Hill Thalís opinion –

## TOD SEPP: Transport Oriented Development Program

### Explanation of Intended Effect: Changes to create low-and mid-rise housing

Ku-ring-gai Council

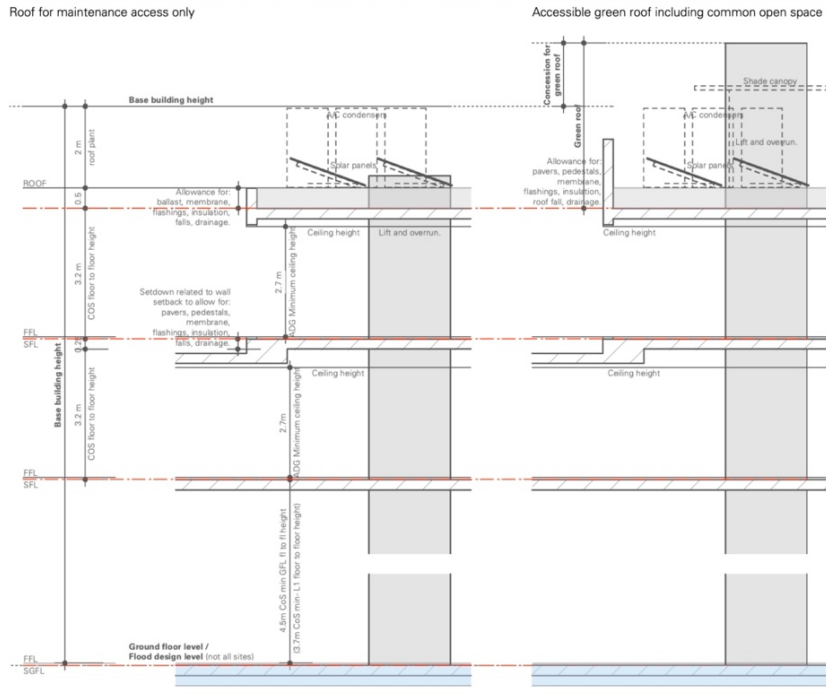
Attention is drawn to Ku-ring-gai's well-established outcomes for residential apartment and medium density developments where the local DCP controls prevail, that continue to deliver on all state housing targets while protecting the LGA's landscape character and critical canopy assets.

The proposed TOD SEPP fails to aspire to this achievement.
